RE: Compliance Inspection  
AFIN: 59-00026; Permit Number: AR0035611

## NPDES Compliance Inspection Report

Subject: DeValls Bluff NPDES AR0035611

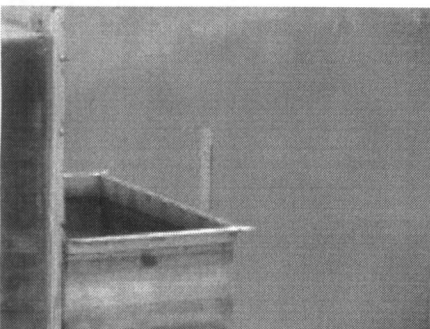
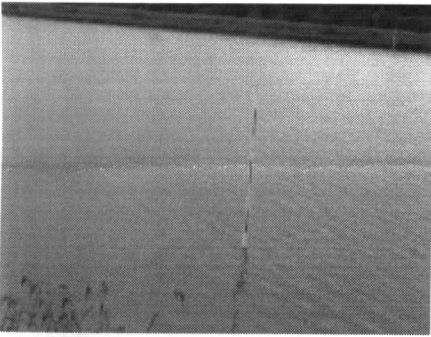
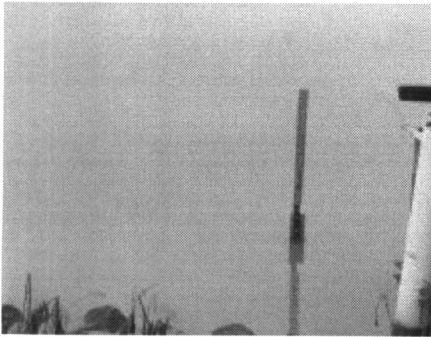
- Please submit documentation of corrective action for items 1, 2a, and 3, and provide a follow-up report to ADEQ regarding activities that have occurred to accomplish corrective actions for items 2b, c, and d in the ADEQ inspection report dated August 1, 2013.

This email is in response to your October 7, 2013 request. Attached please find documentation for corrective action for items 1, 2A and 3 in your inspection report dated August 1, 2013. You will find attached pictures of the staff gauge denoting depths through the weir, pond level gauges and emergency contact information posted at each of six pumping stations.
